UNITED STATES PATENT AND TRADEMARK OFFICE

APPLICATION NO.	FILING DATE	FIRST NAMED INVENTOR	ATTORNEY DOCKET NO.	CONFIRMATION NO.
10/562,027	12/22/2005	Paul Charles Claydon	T4515-16168US01	5558

Office Action Summary	Application No. 10/562,027	Applicant(s) CLAYDON, PAUL CHARLES	
	Examiner ANDREW T. KIRSCH	Art Unit 3781

DETAILED ACTION

Fig.6.

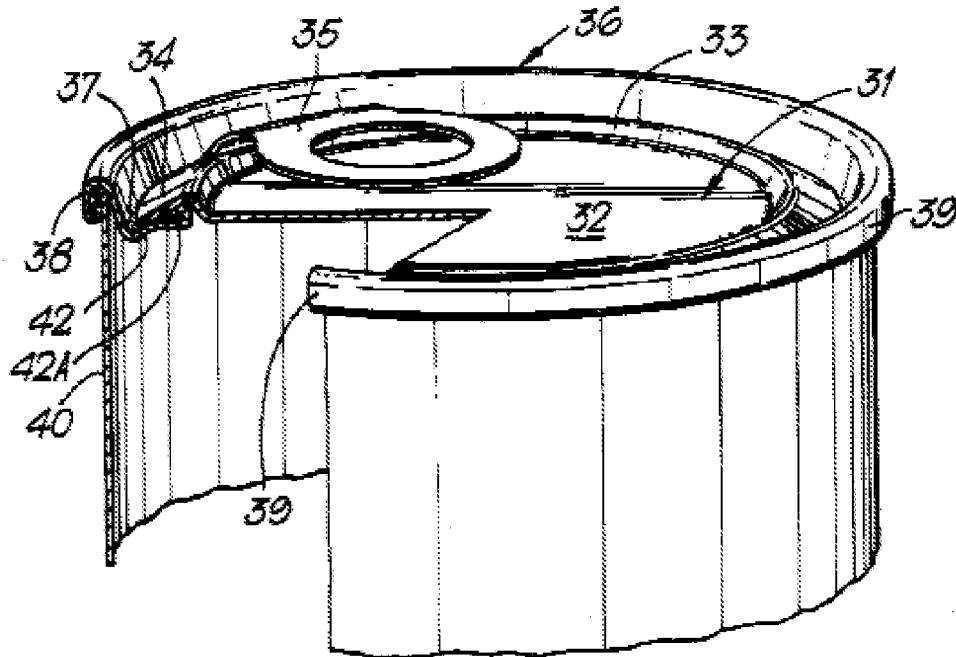
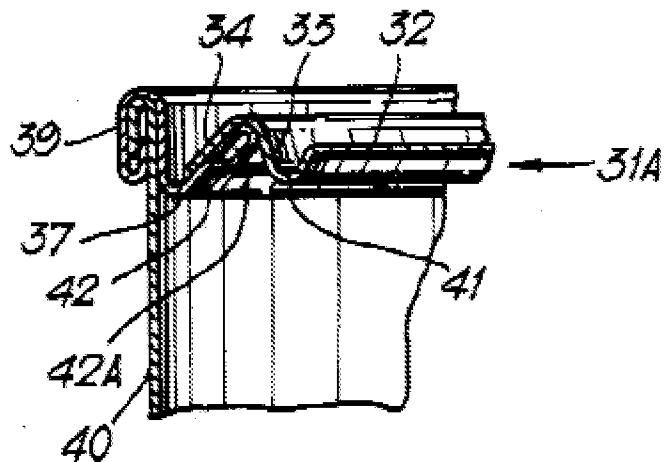
7. In re claim 6, with reference to Figs. 6 and 7 below, Ramsey et al. discloses a product capable of having its in-can pressure controlled during thermal processing, comprising: bonding a panel (31) to an inclined seal surface of an annular component (42), the inclined seal surface of the annular component being initially at an angle of from 10° to 60° (Ramsey discloses an angle of 120° from the wall, which is 30° from the horizontal when measured as in the current application, column 4, line 65); stretching the panel (lid panel “distends” under pressure, column 4, lines 59-62); fixing the annular component and panel bonded thereto to a filled can (column 4, lines 44-55); processing the contents of the filled and closed can by heating to temperatures of up to 135°C (column 4, line 18); and providing, at least during the processing step, a generally dome shaped profile to the panel (“distends”) so as to provide an increase in can volume approximately equal to thermal expansion of the contents and gases in any headspace within the can (column 4, lines 59-62).

11. In re claim 7, with reference to the Figs. above, Ramsey et al. in view of Ball et al. discloses the claimed method further comprising stretching ("distends") the panel into a beaded profile which matches the fibre length of the generally domed shaped profile provided during thermal processing.

15. In re claim 17, with reference to Figs. 6 and 7 above, Ramsey et al. in view of Ball et al. discloses the claimed method further comprising stretching (“distends”) the panel into a beaded profile which matches the fibre length of the generally domed shaped profile provided during thermal processing (as in re claim 7 above).

16. In re claims 18 and 19, with reference to the Figs. above, Ramsey et al. in view of Ball et al. discloses the claimed invention including wherein the inclined seal surface of the annular component is initially at an angle of from 20° up to 45° (30°, as in re claim 16 above).

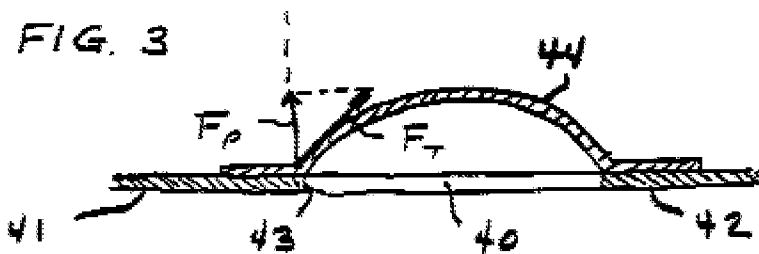
9. However, with reference to Fig. 3 below, Ball et al. teaches how the application of a shallow flange angle (planar flange), with the introduction of in-can pressure, results in a peeling force (F_T), inherently reducing the force to peel the closure required by a user.

10. Therefore, it would have been obvious to one of ordinary skill in the art at the time of the invention to have modified the method of Ramsey et al. by adding a step which flattens the annular flange for the purposes of reducing the applied peel force required by the user as taught by Ball et al. Note that since both configurations of the flange are disclosed in the prior art, it would have been obvious to have included the step of re-configuring the flange from the one known state to the second known state to achieve the known advantages associated with each state.
